DUKE POWER COMPANY

Re: McGuire Nuclear Station  
Docket Nos. 50-369 and 50-370

REQUEST FOR ADDITIONAL INFORMATION  
REGARDING NUREG-0737 ITEM II.D.1  
FOR  
MCGUIRE  
UNITS 1 AND 2  
DOCKET NOS.: 50-369 AND 50-370

FIGURE 1 DUKE MCGUIRE PRESSURIZER  
 RELIEF LINE RELAP 4/MOD 5 MODEL

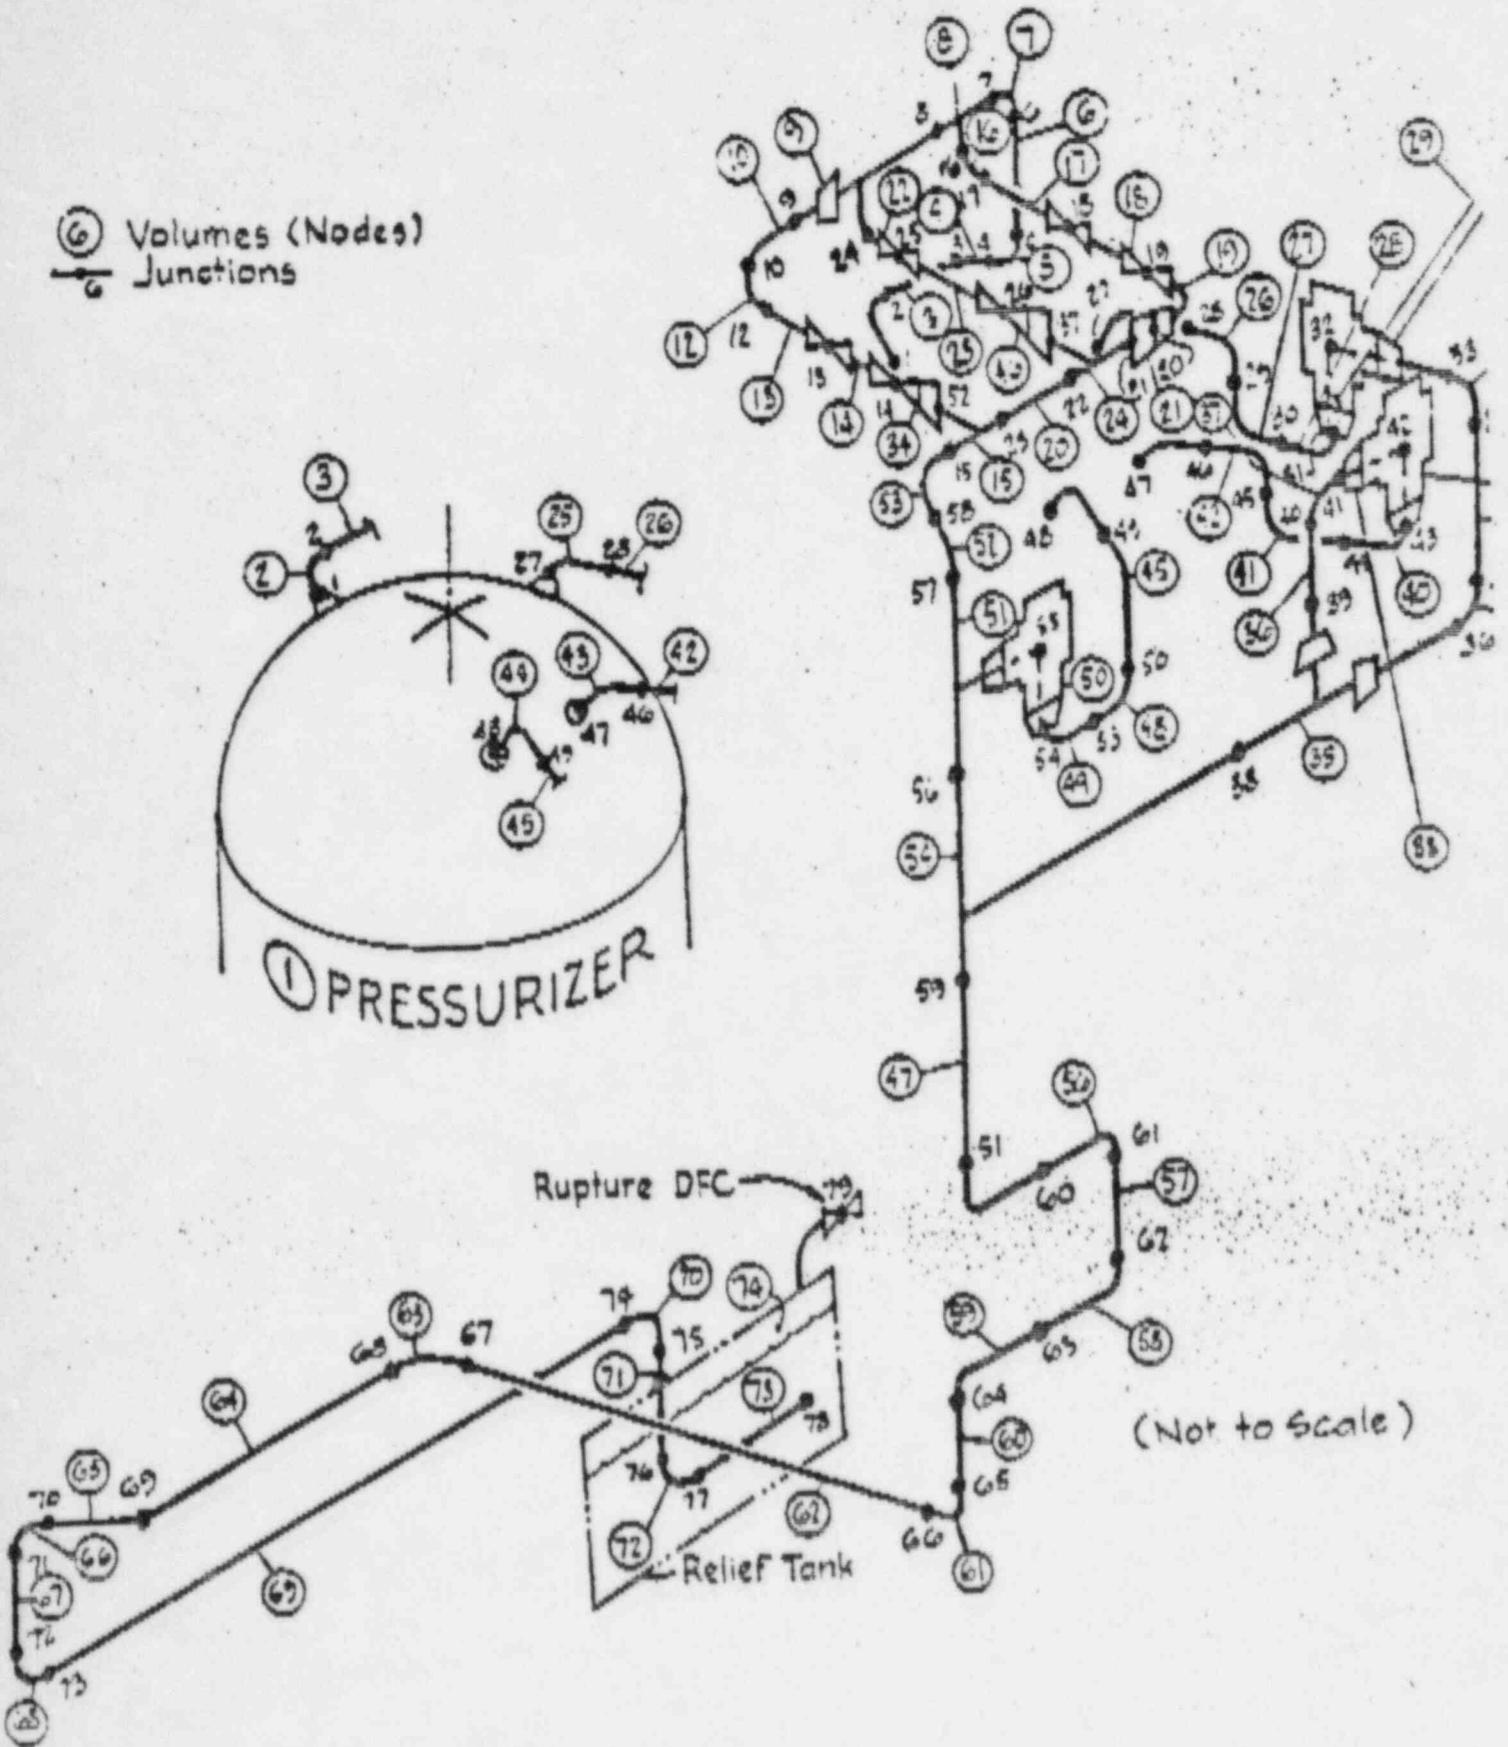
- (e) A discussion of the sequence of opening of the safety valves that was used to produce worst case loading conditions.
- (f) A sketch of the thermal hydraulic model showing the size and number of fluid control volumes.

- (f) The thermal hydraulic model sketch is shown in Attachment A.
- (g) The report is available at DPCo/Design Engineering Department.

Attachment B

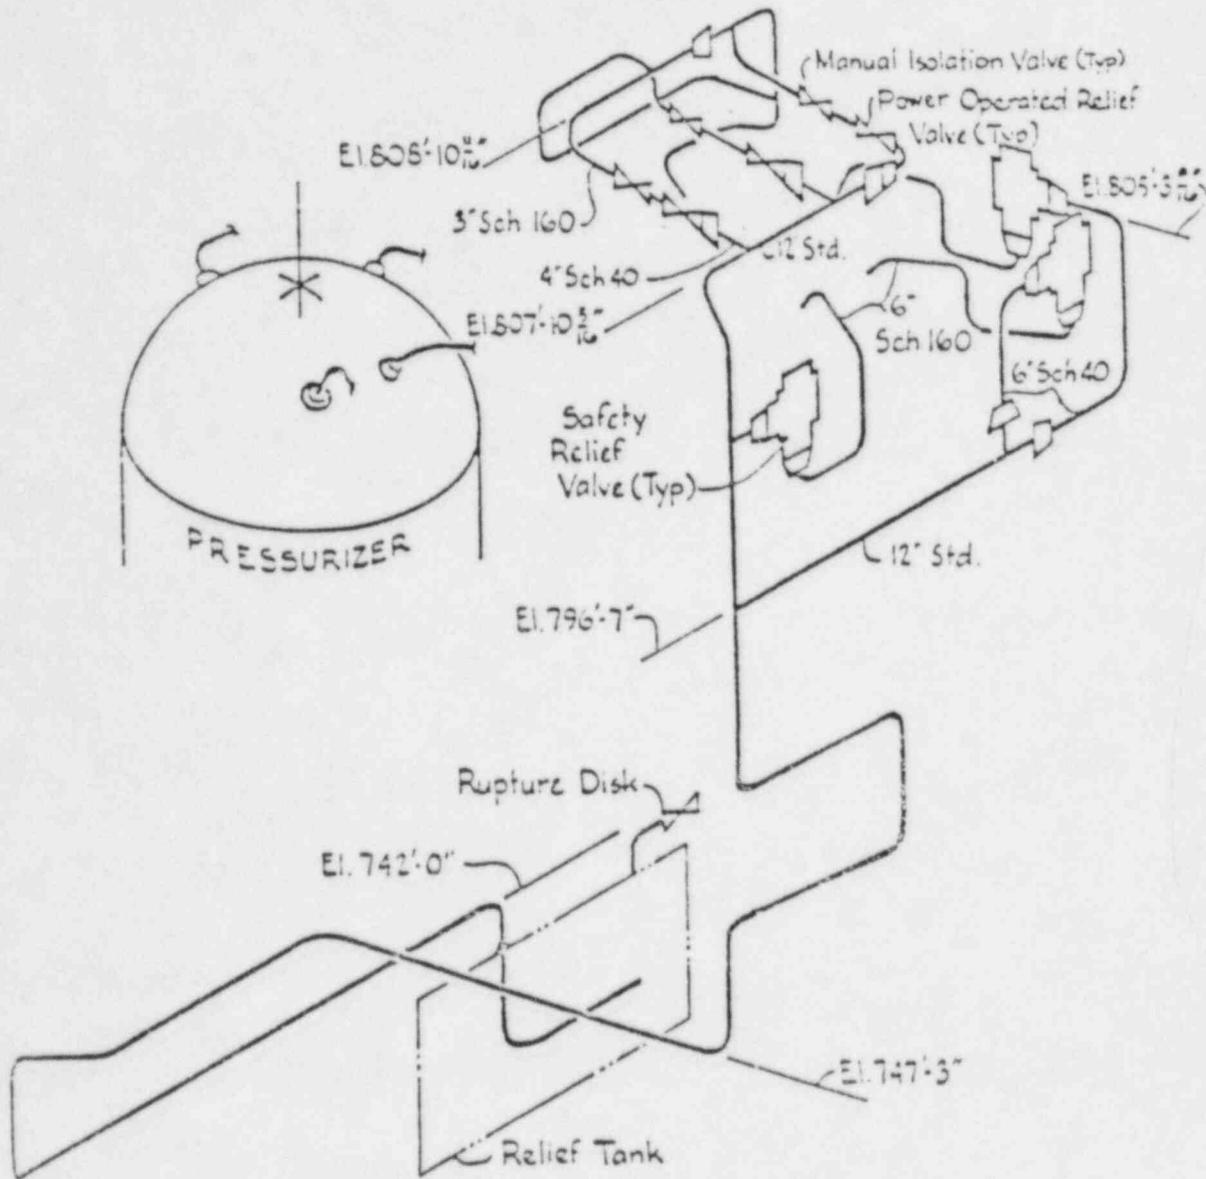
- (f) A sketch of the structural model showing lumped mass locations, pipe sizes, and application points of fluid forces.
- (g) Identify where a copy of the EDS Nuclear, Inc. structural analysis report may be obtained.
